WHEELER SEABECK RESIDENCE

COVAL HOMES PLAN - OLYMPIC

Reviewed for code compliance
with IRC 2015
Kitsap County Building Department
GShapiro@co.kitsap.wa.us
05/05/2020

7 Roof Plan
1/8" = 1'-0"

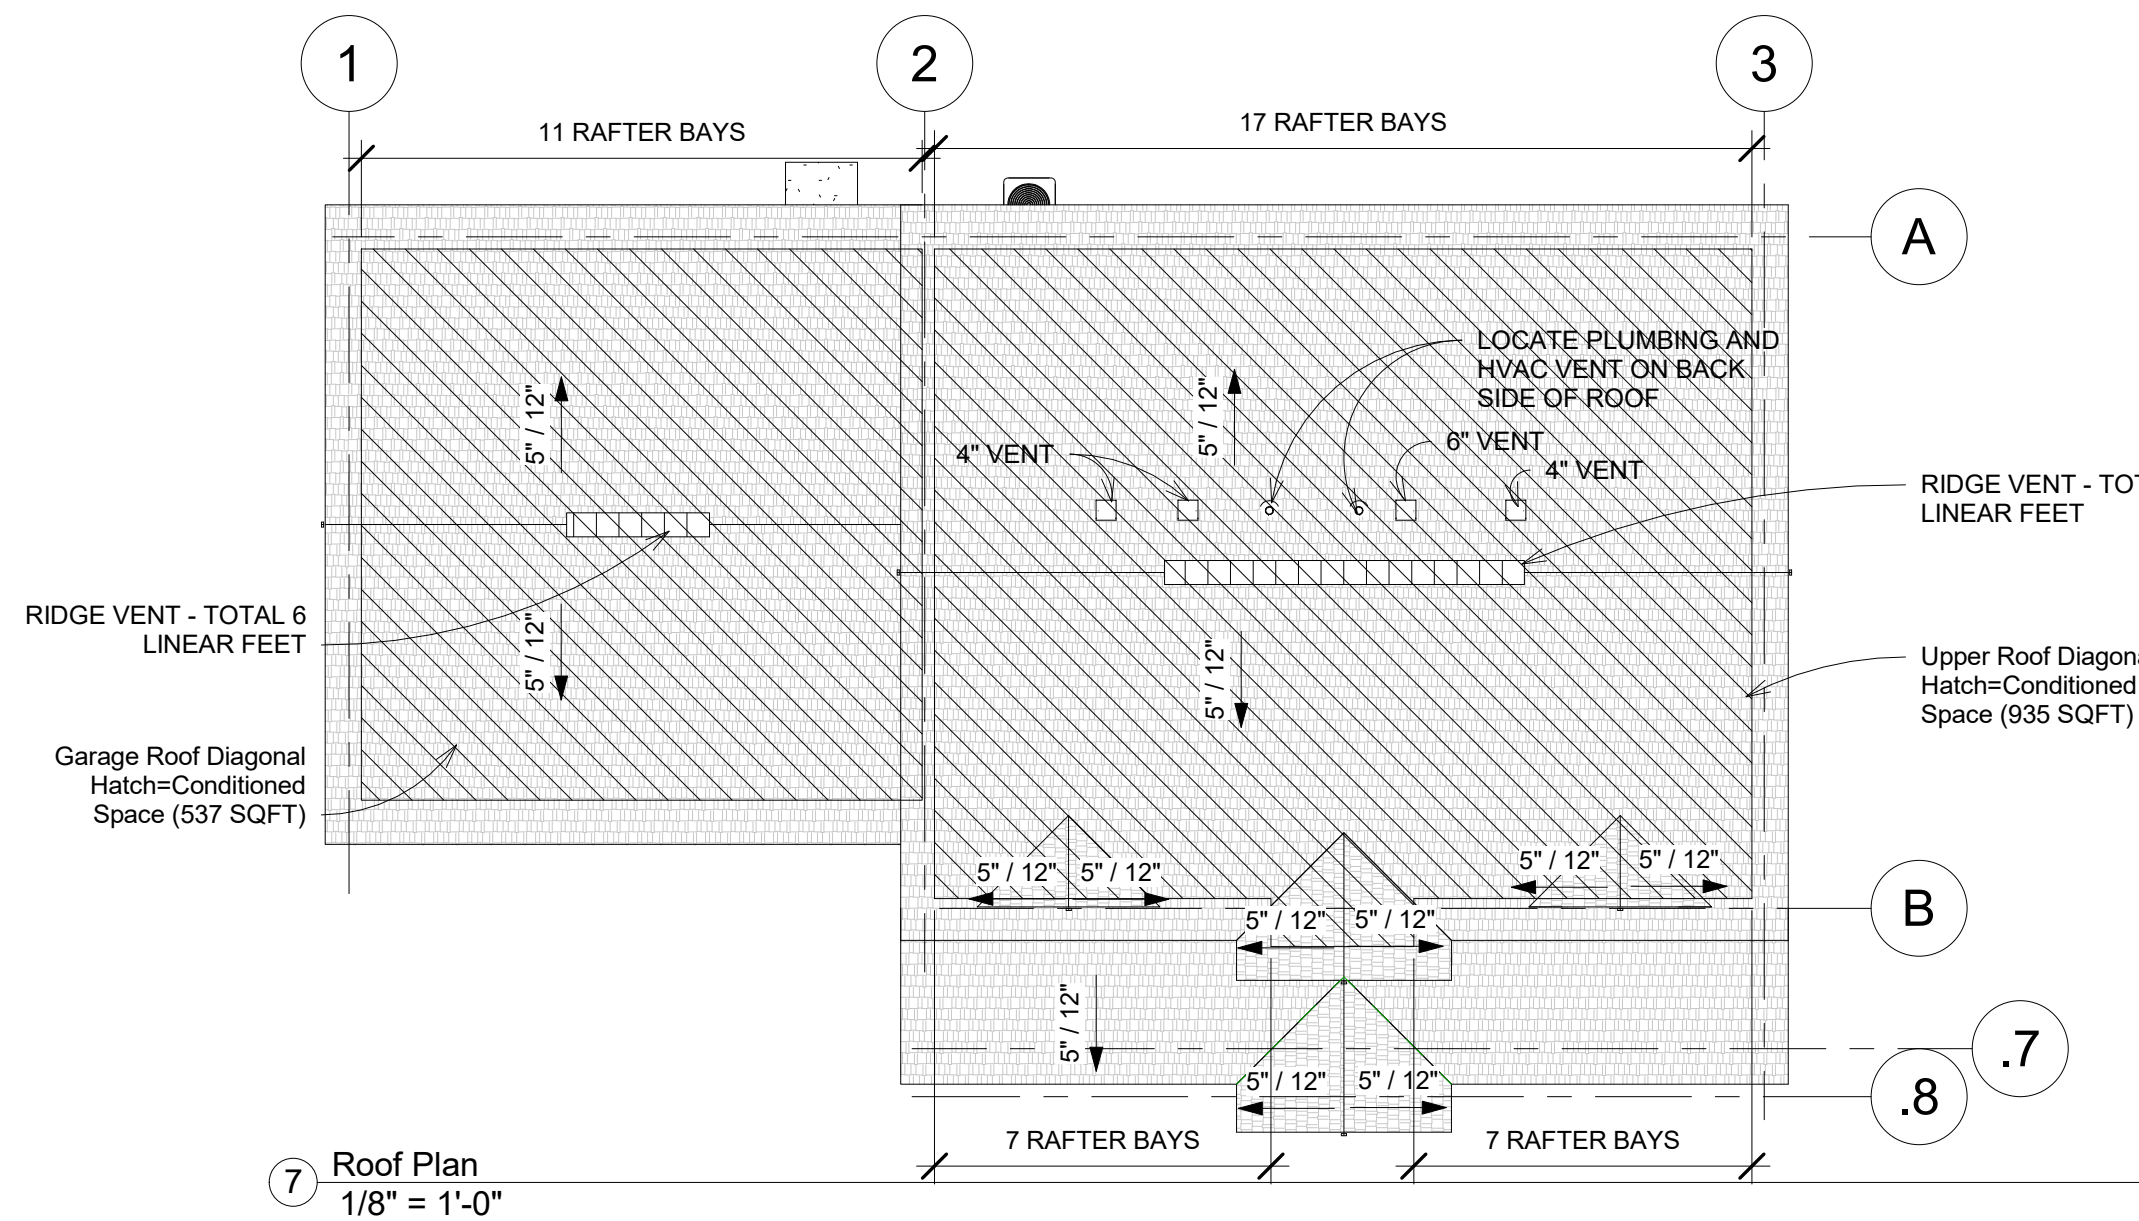
Gutters and downspouts are required.
All roof and yard drains shall be directed to splash blocks at a minimum,
or to an infiltration system if required. All surface drainage shall have a
minimum 2% grade away from the foundation.

① Level 1 Electrical
1/4" = 1'-0"

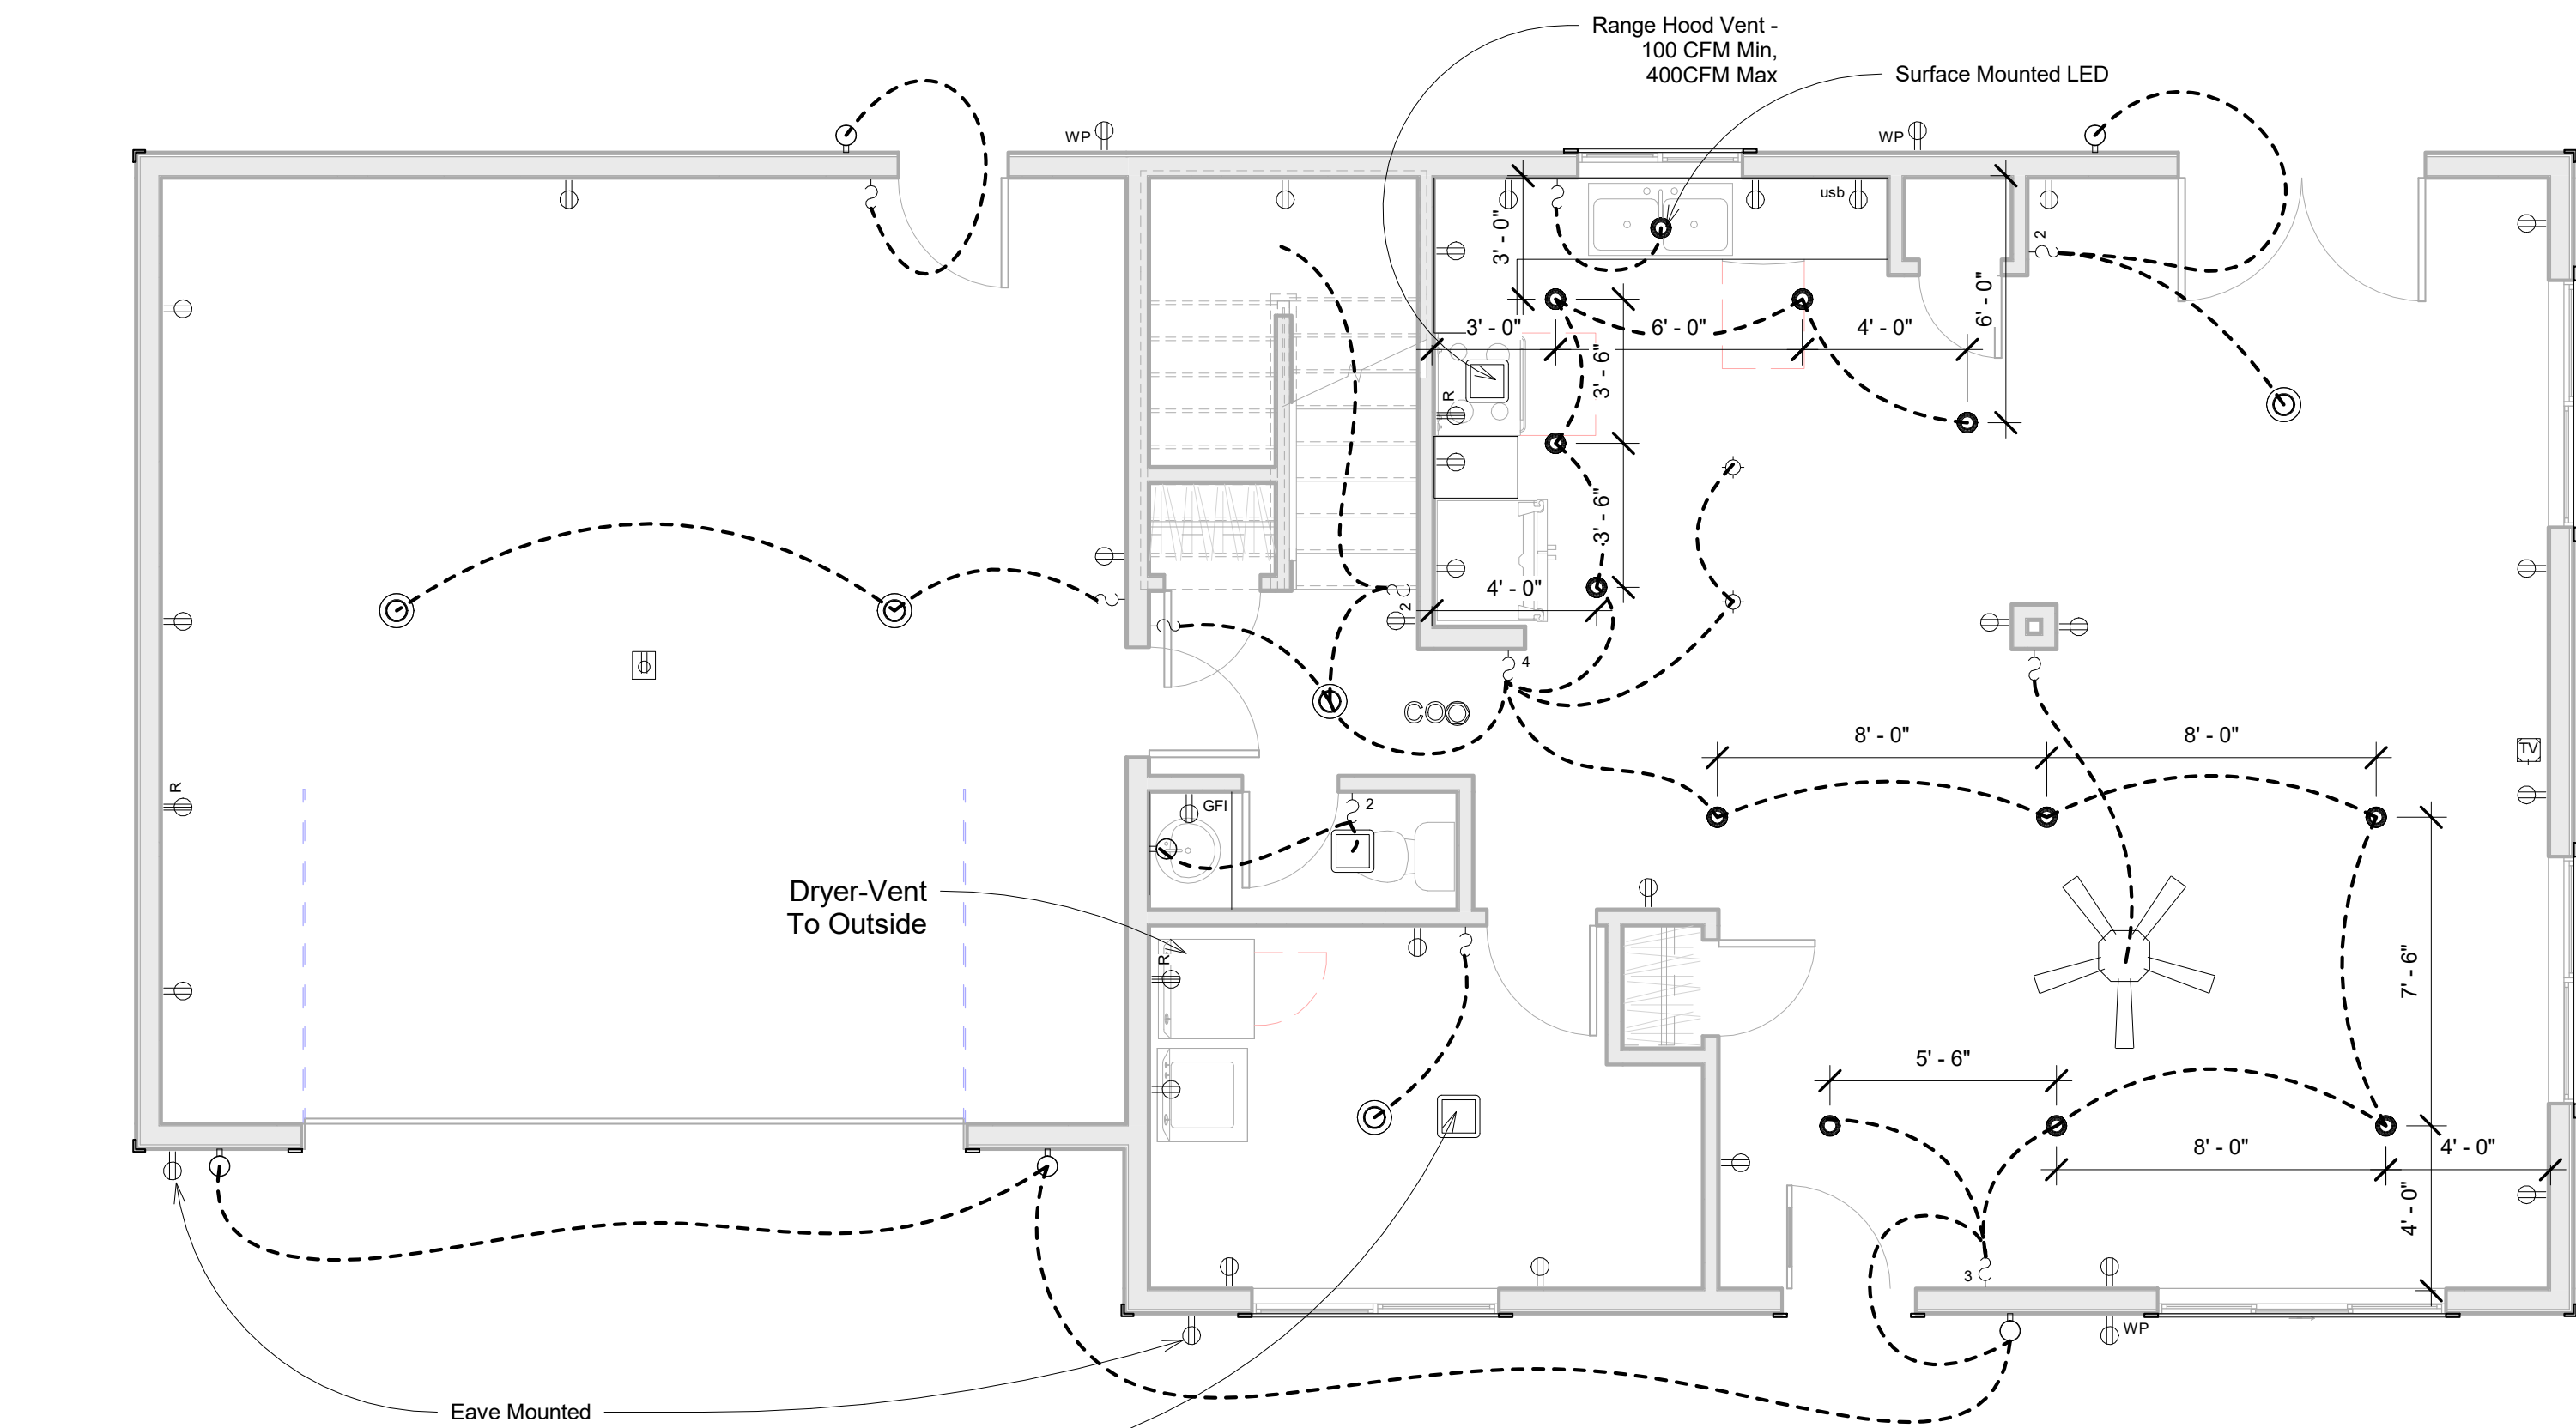
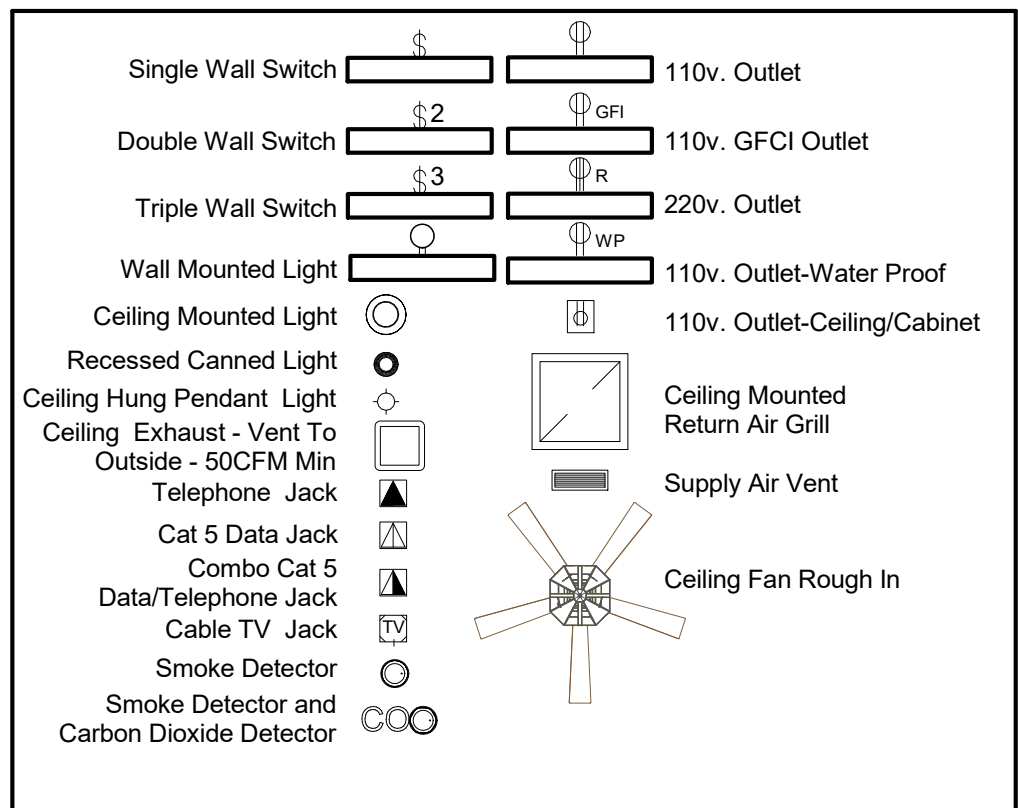
Smoke & carbon monoxide detectors required.
Smoke and carbon monoxide detectors must be
installed throughout the building in all locations
required by the IRC as amended by WAC.

Range hood exhaust cannot exceed 400 CFM
or additional measures must be taken per IRC

Opt. 2nd Floor / Low Roof Framing Plan

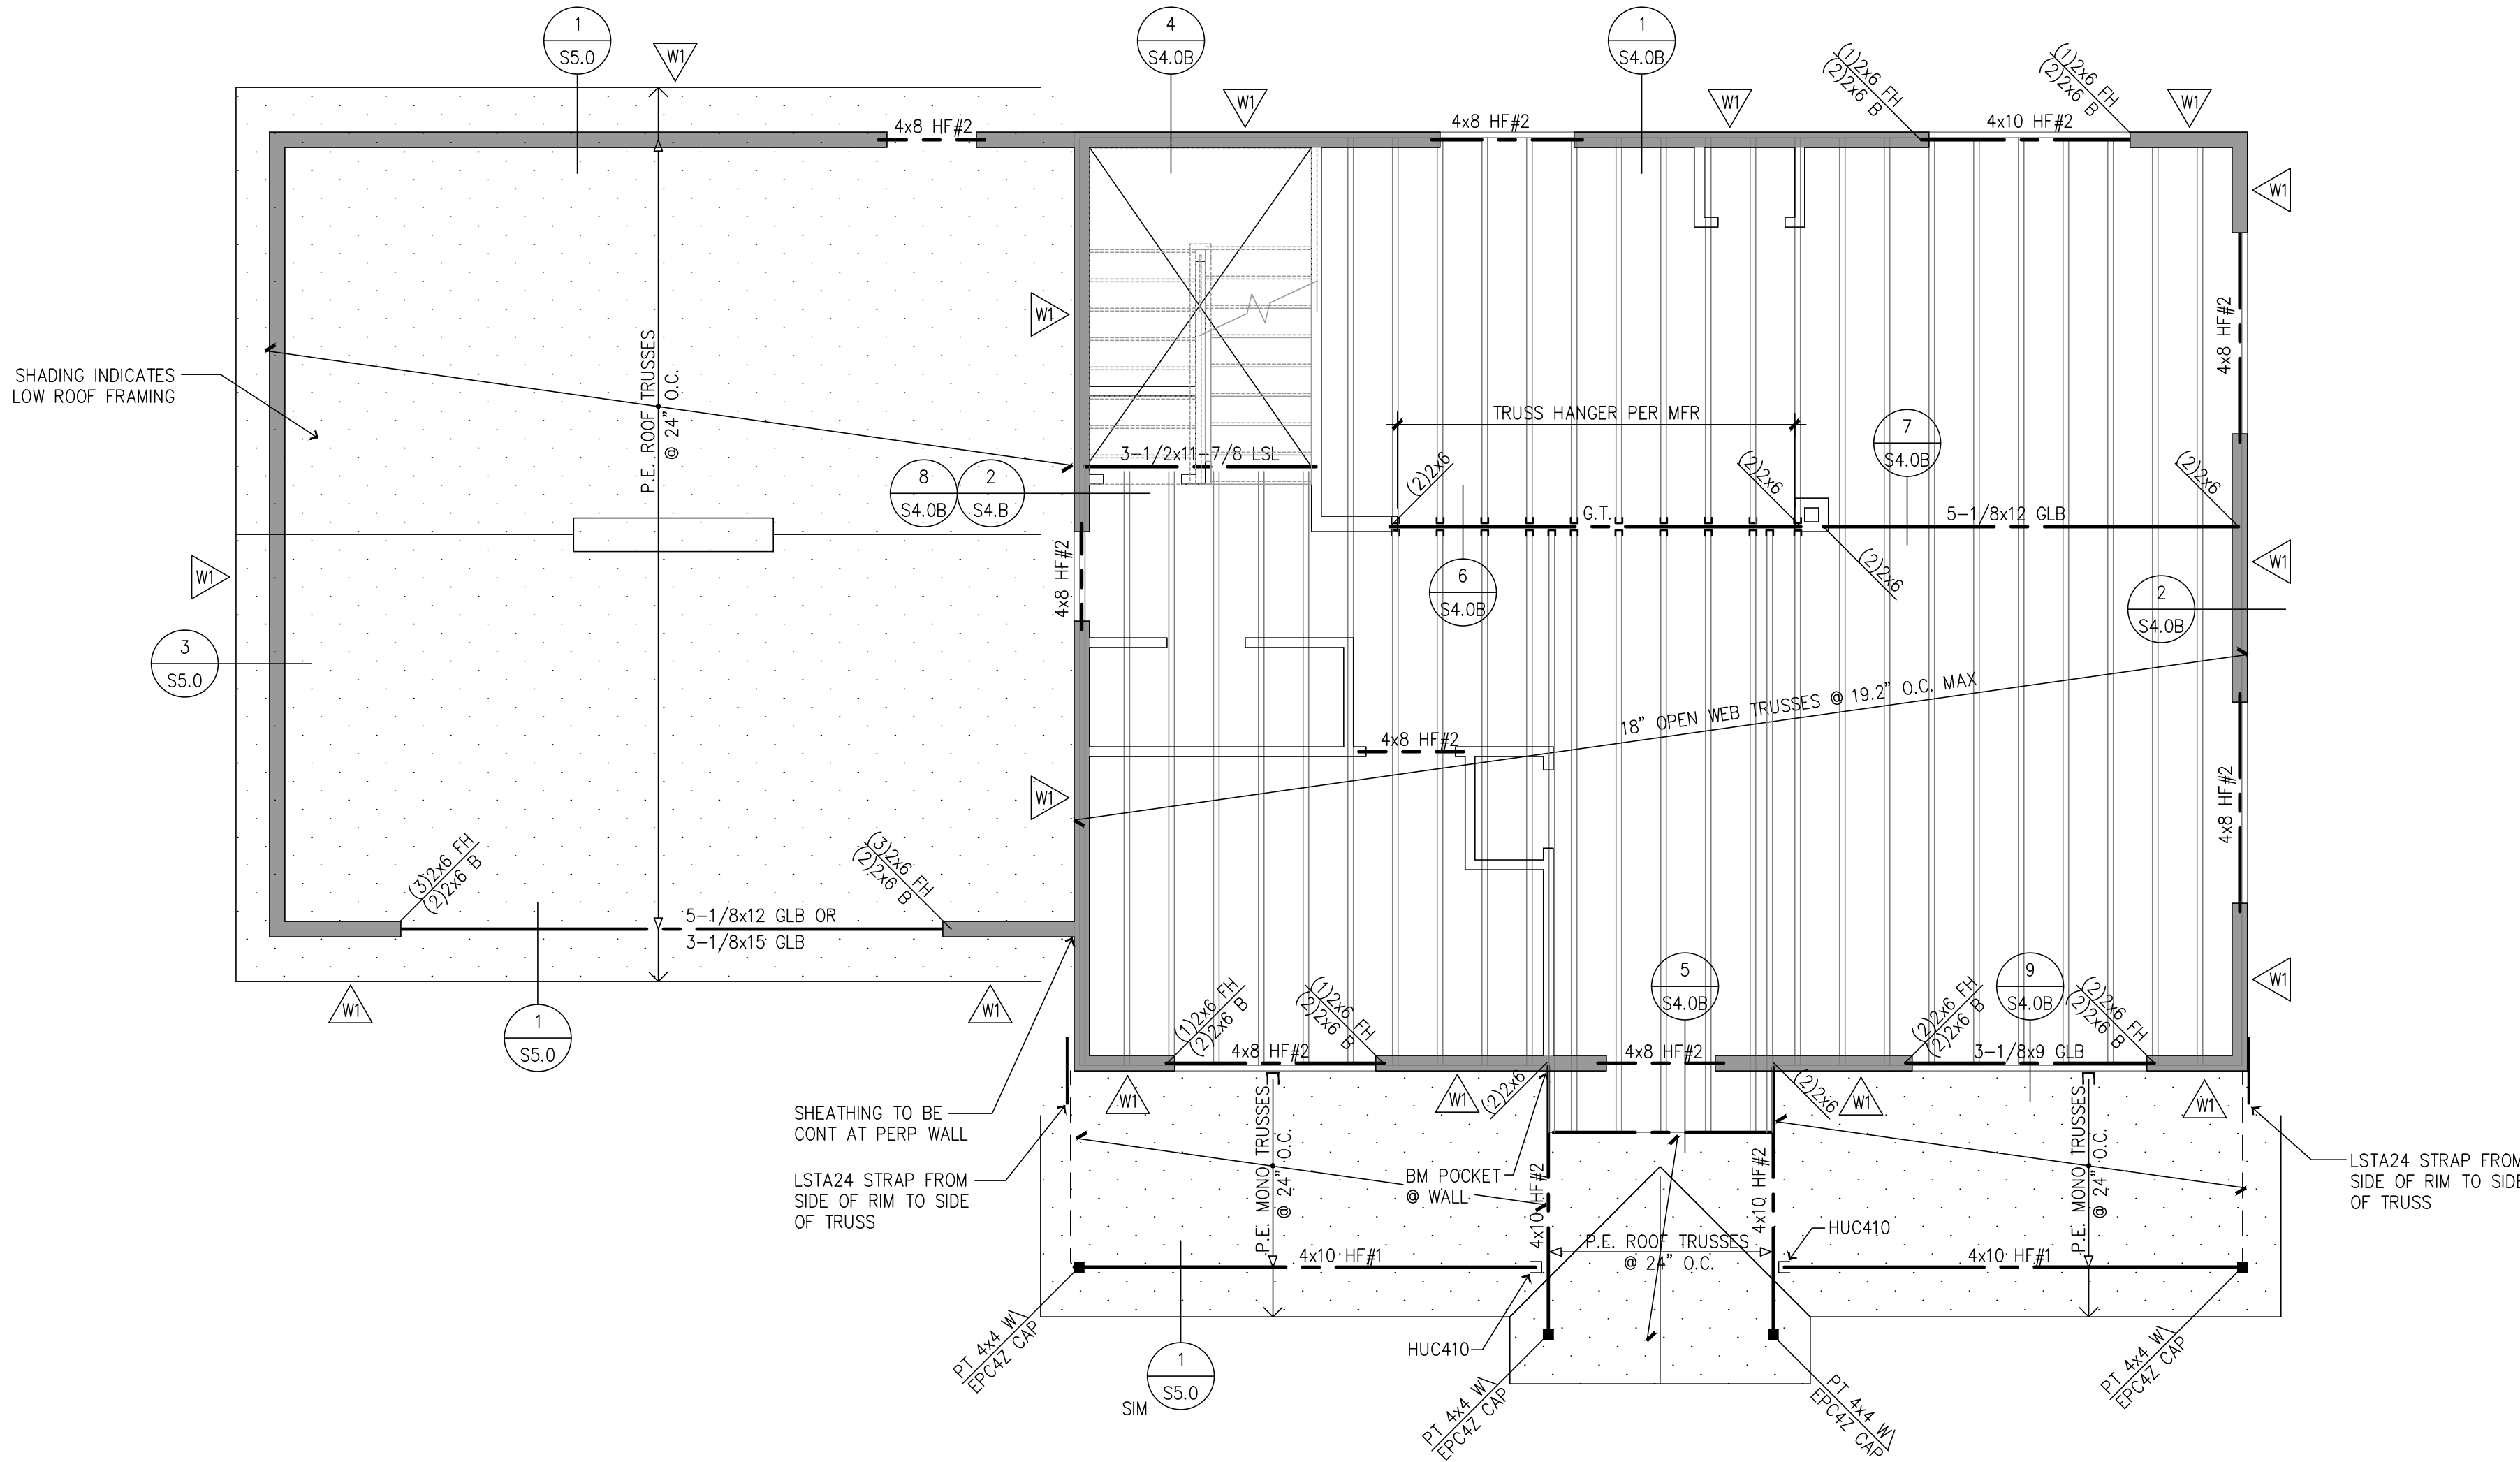
Manufactured joist specs
shall be on-site for inspection
